January 26, 2024  
IDEA Donna Mechanical Upgrades

## ADDENDUM NO. 1

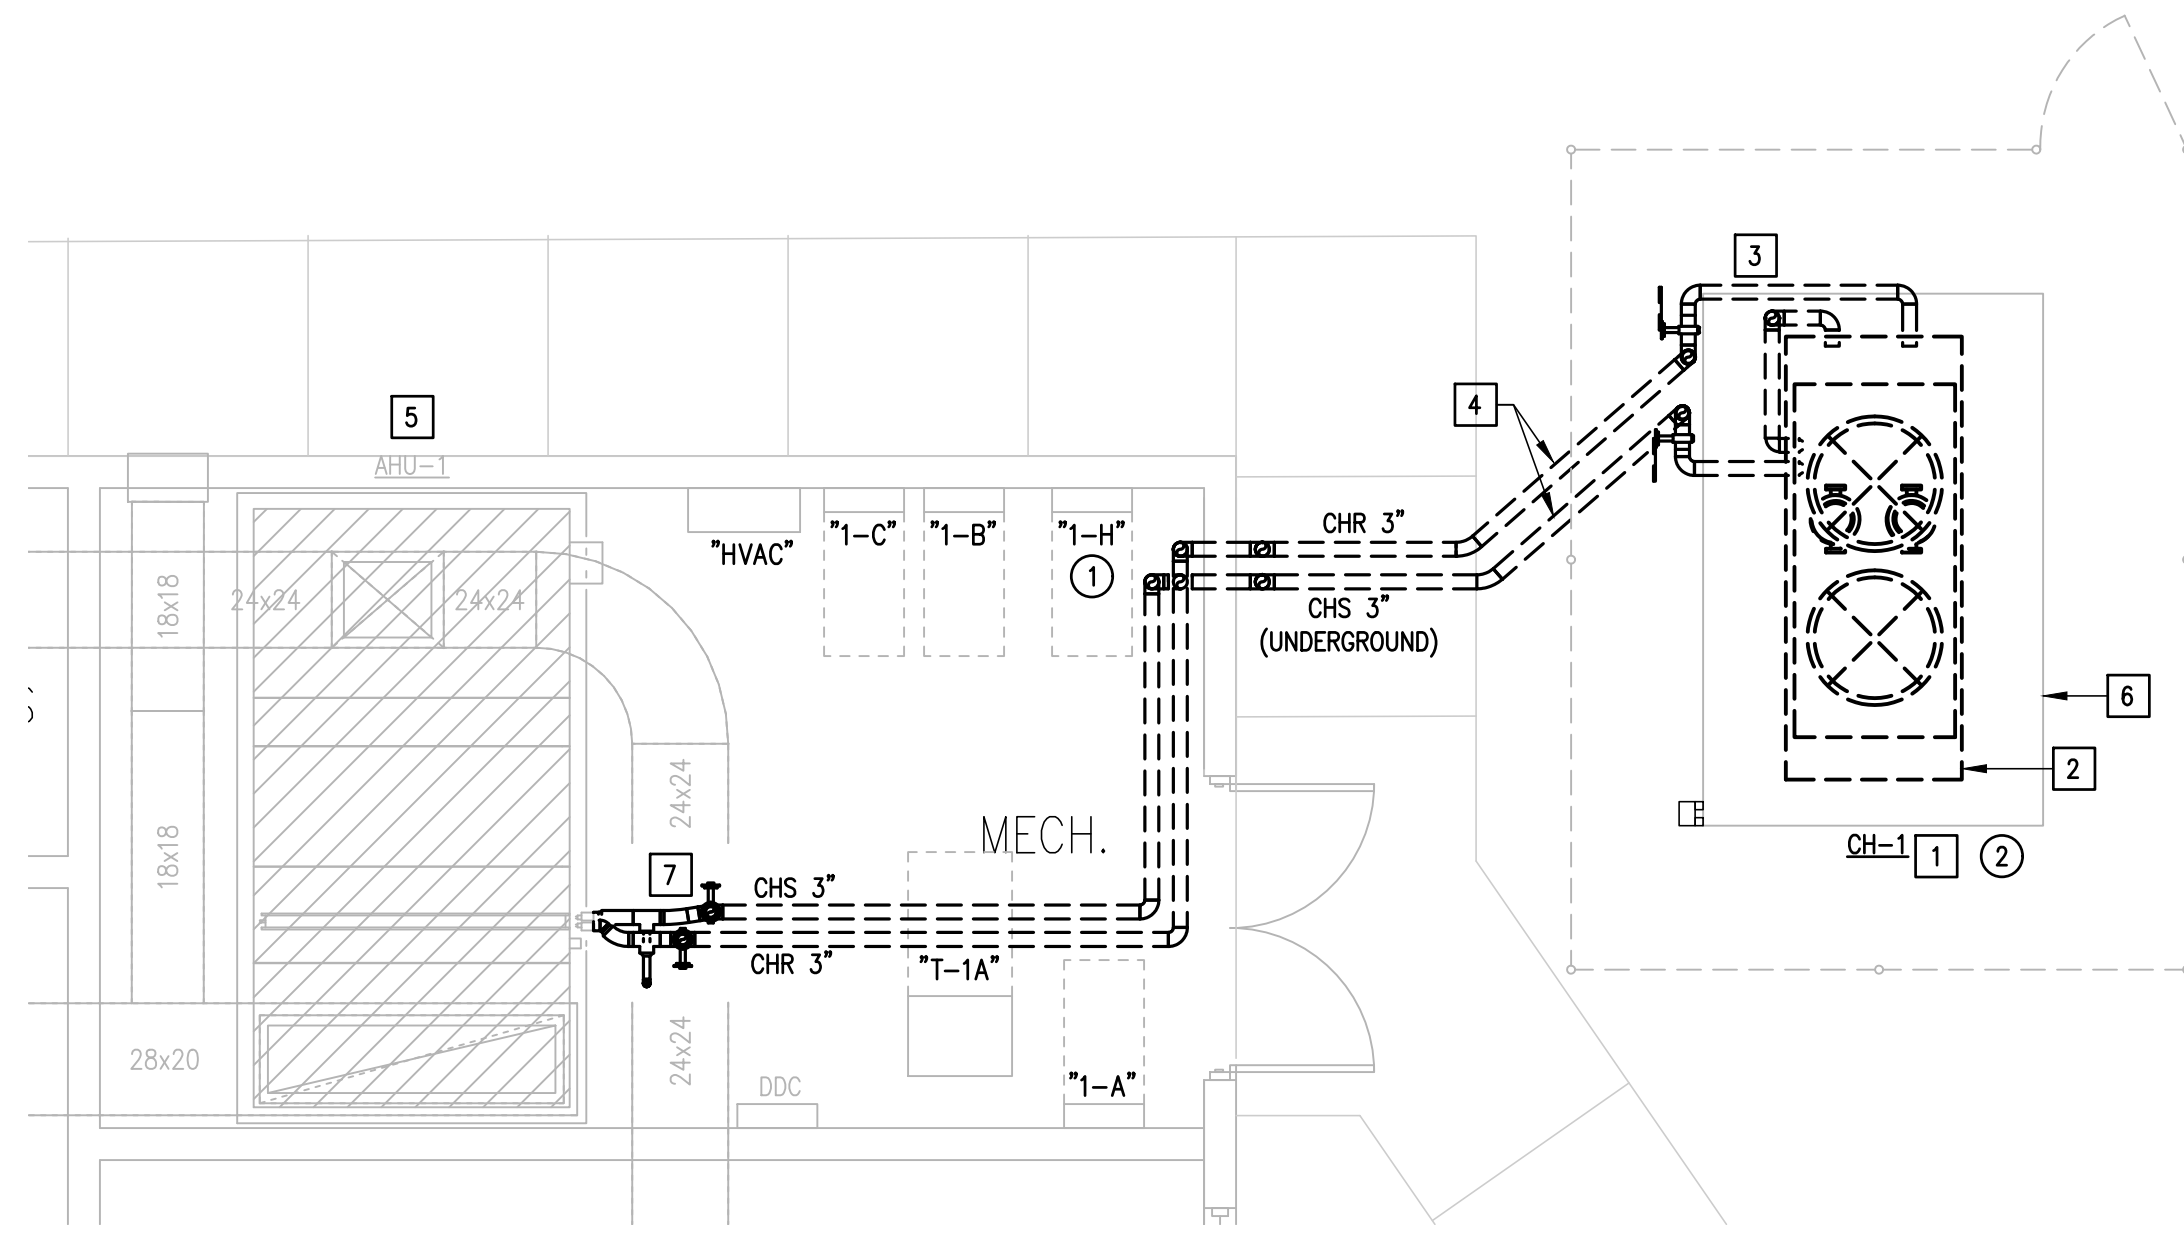
1. Sheet ME0.01:
  - a) Added mechanical symbols legend. See attached sheet.
2. Sheet ME1.01:
  - a) Revised Alternate #1 Mechanical & Electrical Plan. See attached sheet.
  - b) Revised Electrical Alternate #1 Demolition Keyed Notes.
3. Sheet ME1.02:
  - a) Revised Alternate #1 Mechanical & Electrical Plan. See attached sheet.
  - b) Revised Electrical Alternate #1 Demolition Keyed Notes.

**IDEA DONNA CAMPUS - ALTERNATE #1  
NEW MECHANICAL PLAN (9TH GRADE BUILDING)**  
01 SCALE : 1/8" = 1'-0"

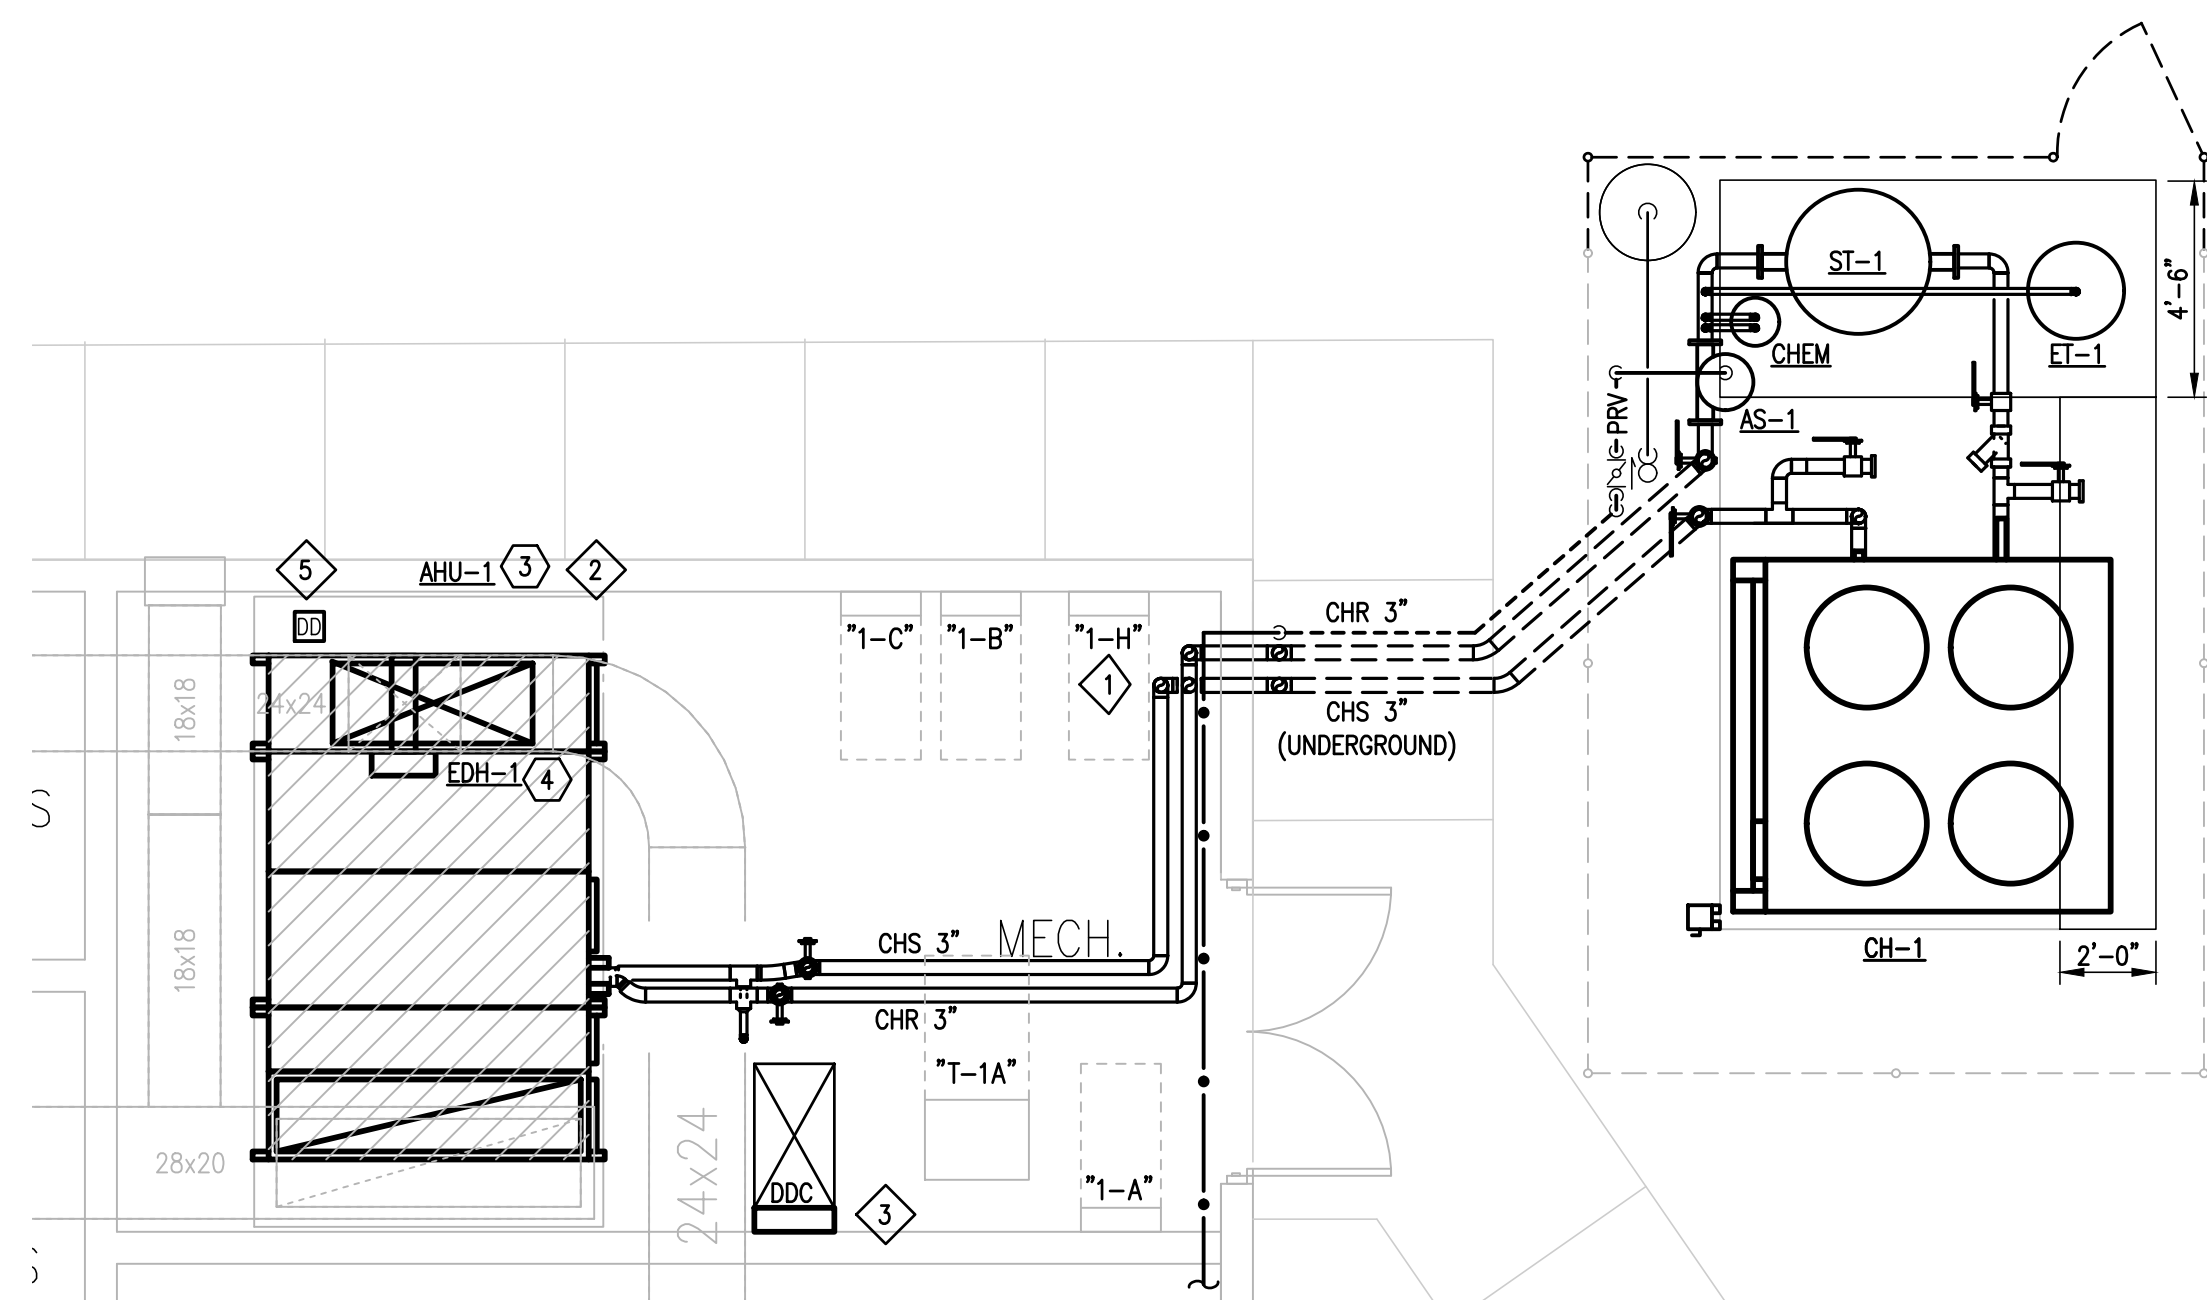
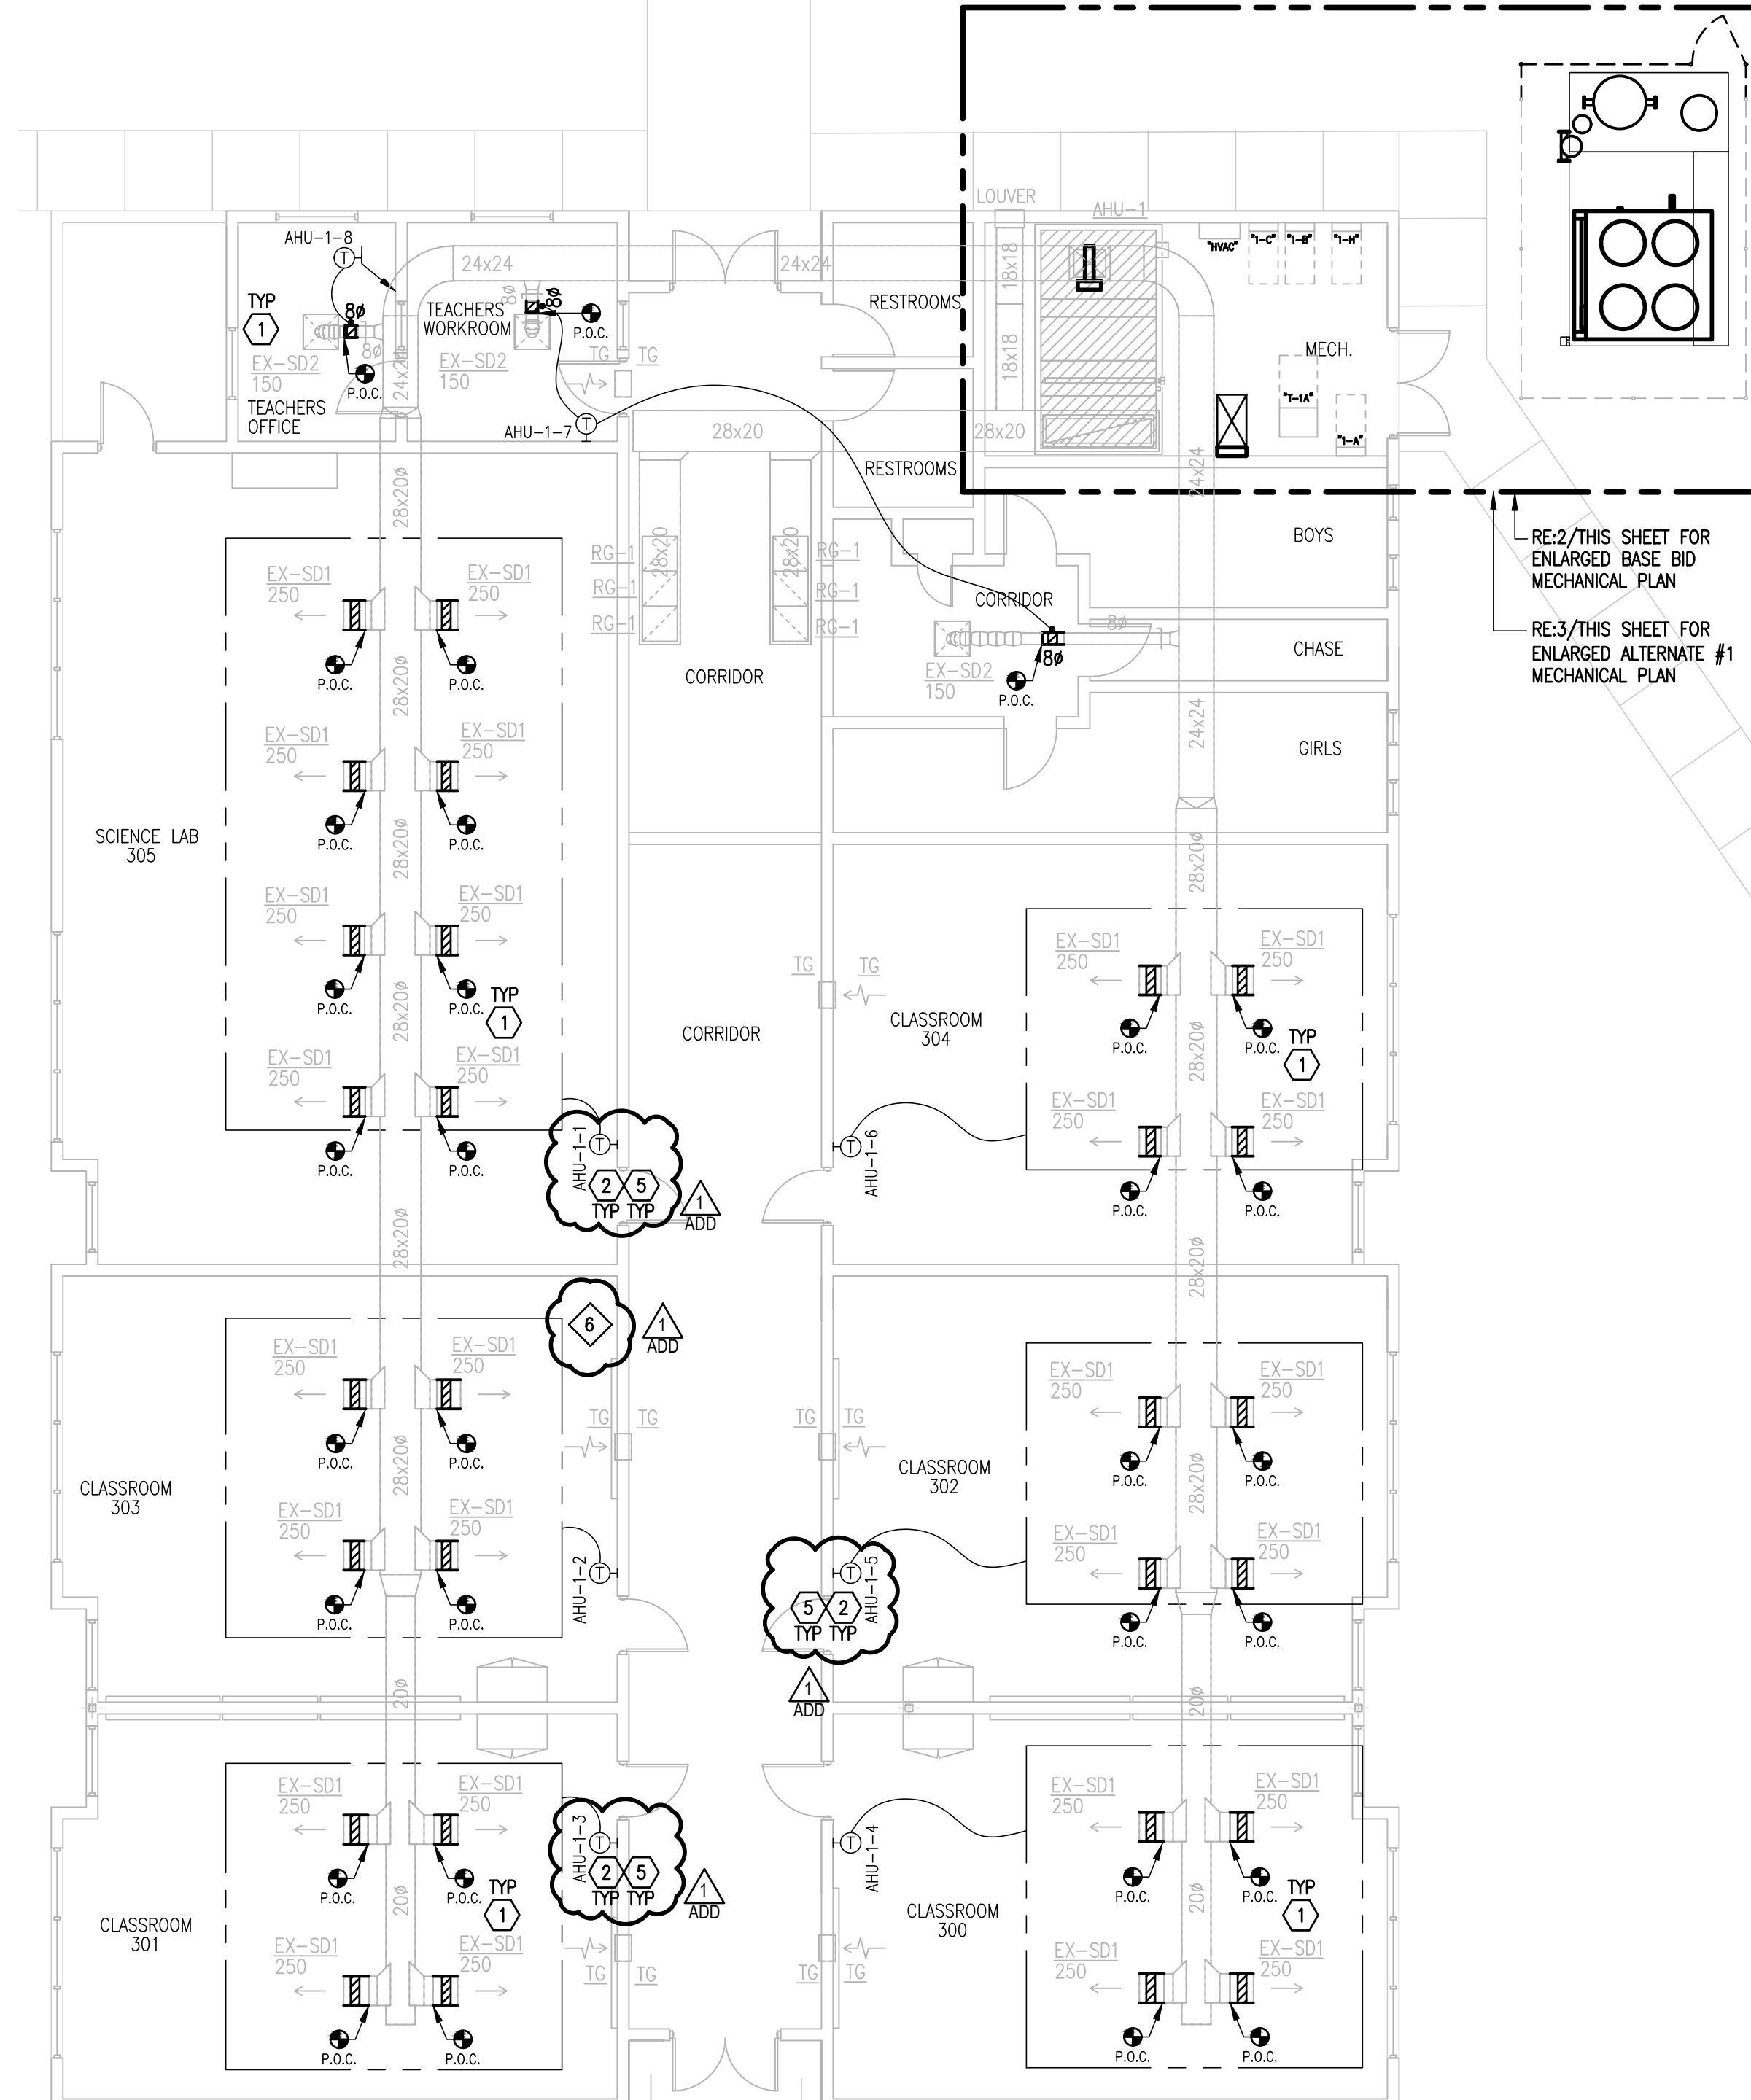
4. Sheet ME2.01:
  - a) Revised Alternate #1 New Mechanical Plan. See attached sheet.
  - b) Revised Alternate #1 Electrical Keyed Notes. See attached sheet.
